Agenda Item Number: 1 Project #: PR-2020-004639 Case #: SI-2022-01303 Hearing Date: August 18, 2022

Staff Report

Request Site Plan- EPC for an Extraordinary

Legal Description Tracts A-1-B, Candelaria Farm Area

- 1. Site Plan
- 2. Landscape Plan

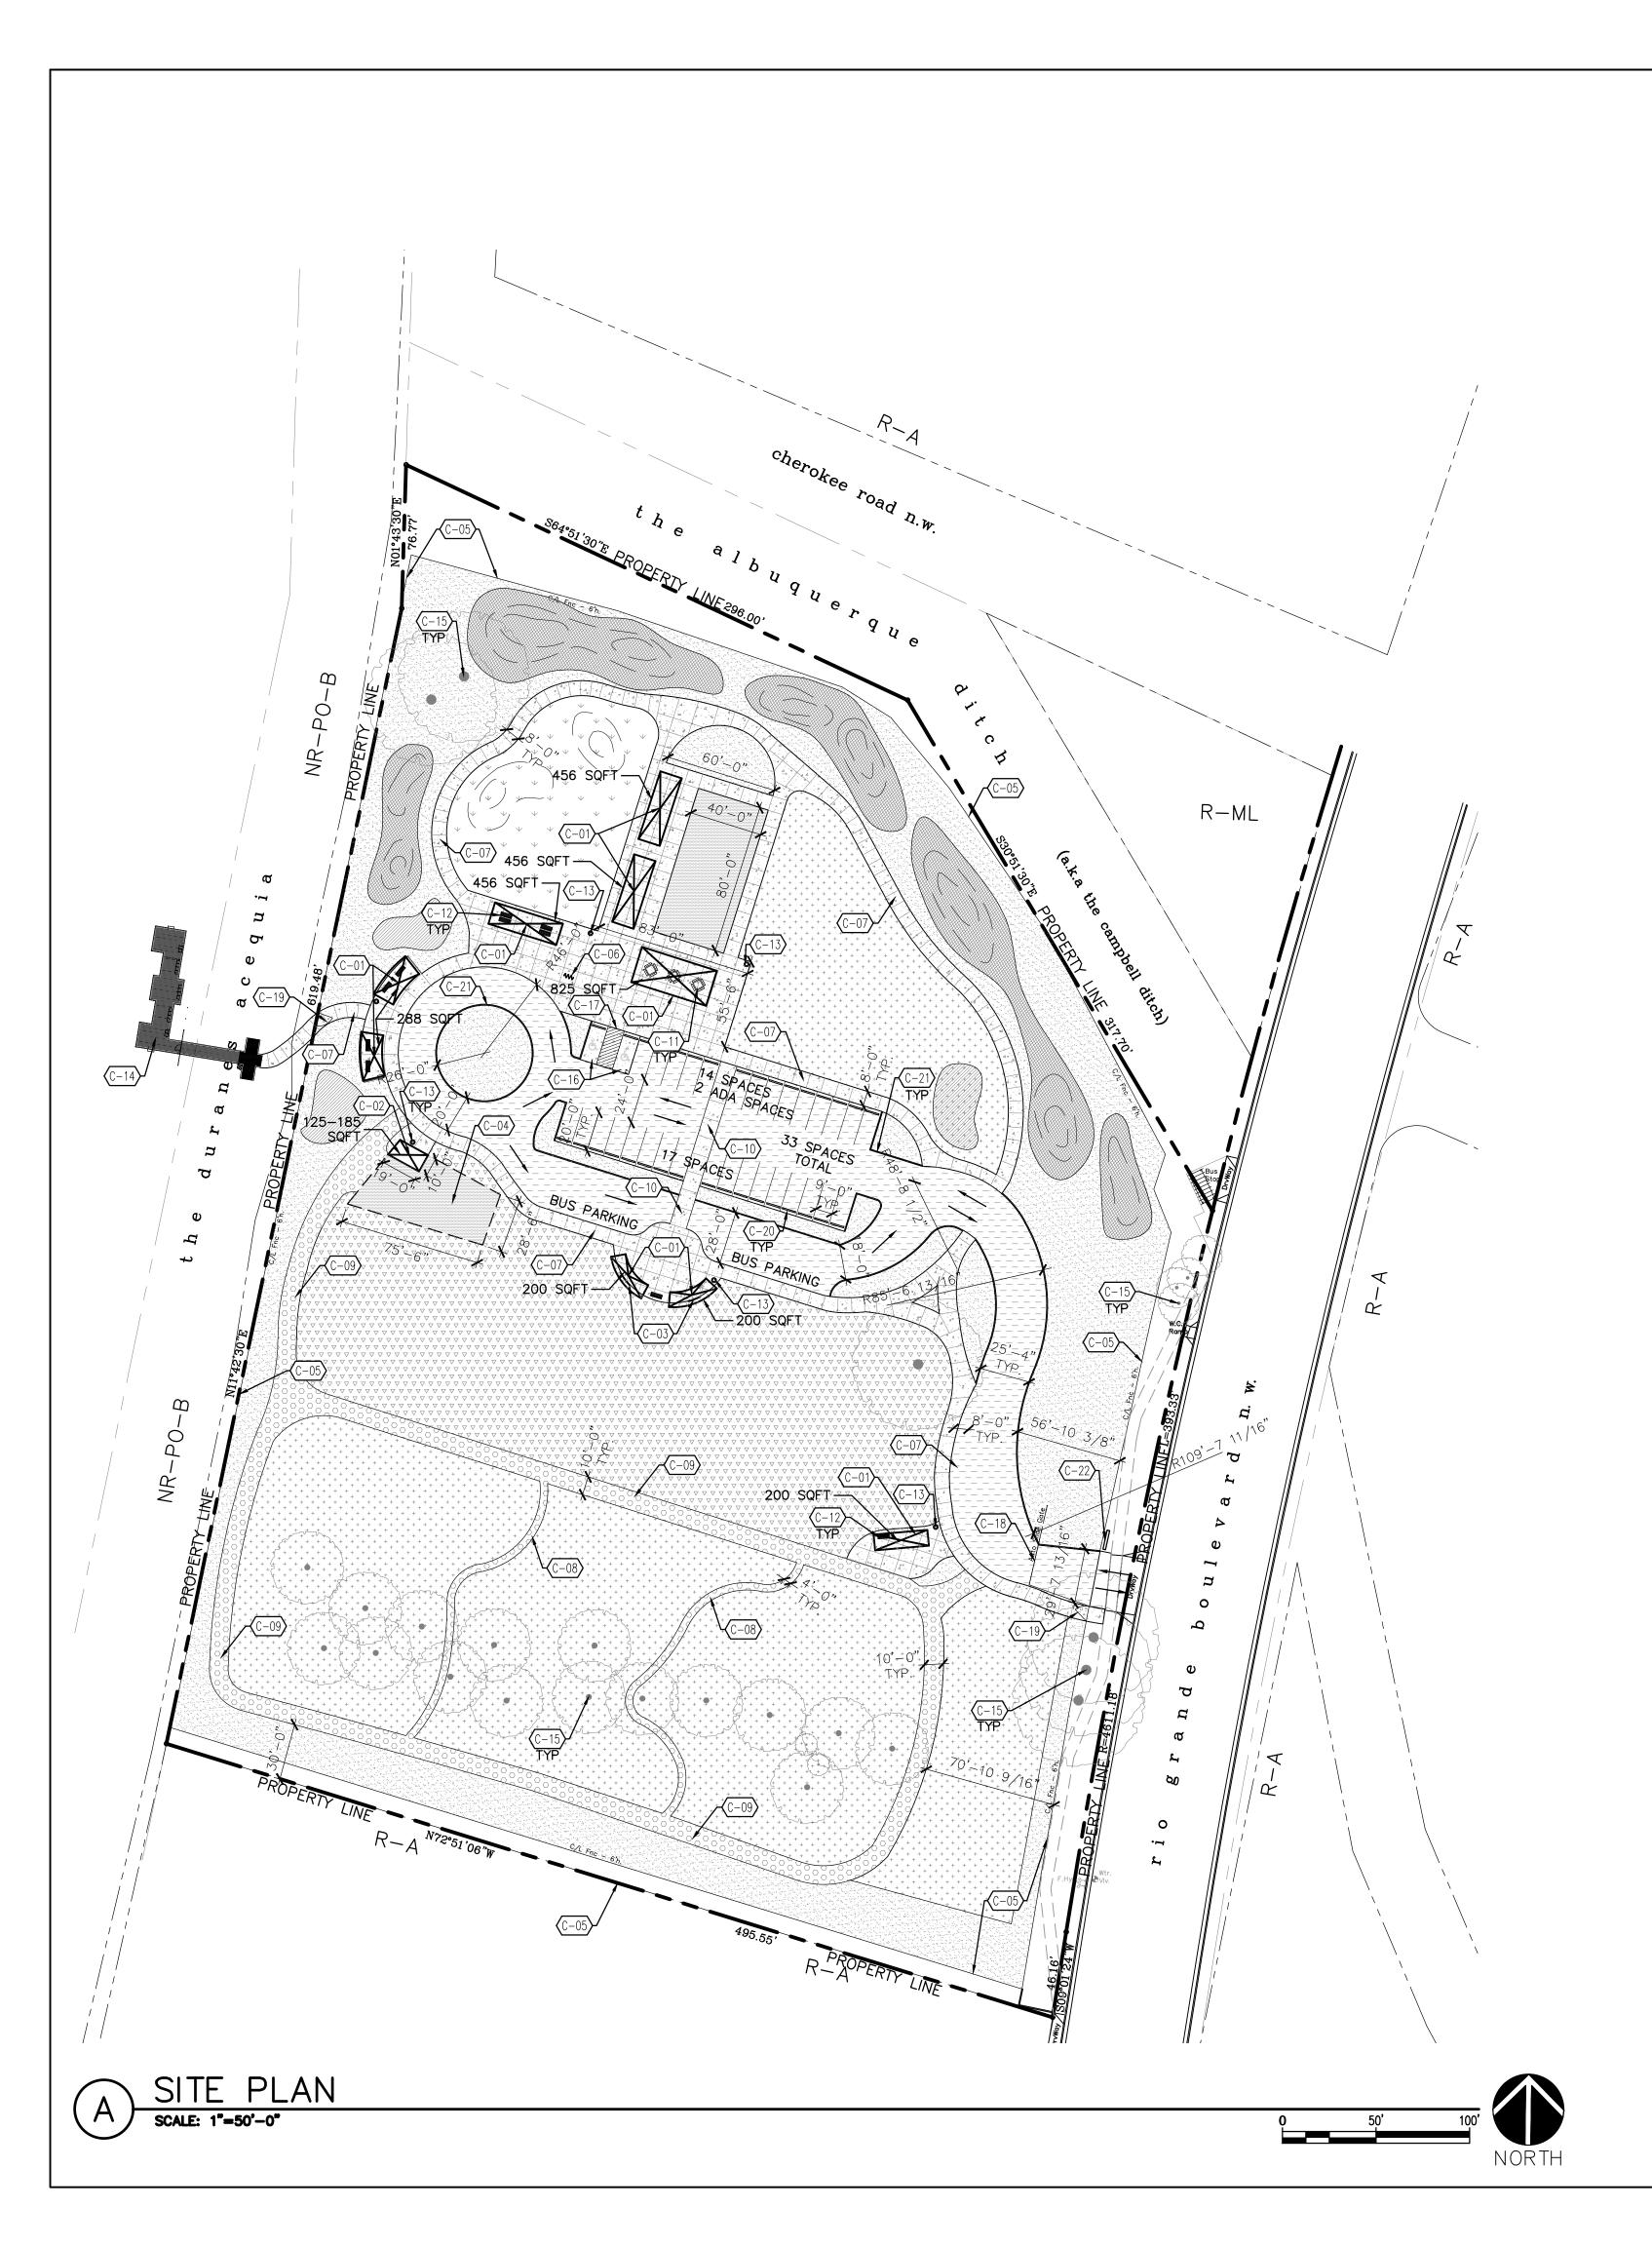
Site Keyed Note #1 of the Site Plan lists that there will be a shade structure 9' high. Materials will be steel and natural materials and colors. No details have been provided of the shade structure and LRV value. Staff will craft conditions of approval to create compliance as needed and to provide clarity for the future.

No illuminated or motions signs are proposed. The only signage that is proposed is for a monument sign listed on the site plan. No specific plans have been developed to date related to the monument sign. Staff will craft conditions of approval to create compliance as needed and to provide clarity for the future.

The site plan lists that the Duranes lateral runs along the western border of the subject site.

No grading plans have been provided.

Elevations have not been submitted at this time. The applicant has submitted as part of the site plan precedent images for bathroom facilities but those details have not been finalized as of the writing of this report.

- 1. Please add MRGCD signature line with other signatories on page 1.
- 2. Please add MRGCD Approval Note to page 1 of site plan.
- 3. MRGCD Amounts Due; contact Assessments Dept to make payment.
 - 4. Please add MRGCD R/W information to match MRGCD records; and survey toe to toe showing total width of ditches as well as the property line to the centerline.
- 5. Final Plat Approval Signature required by the MRGCD.
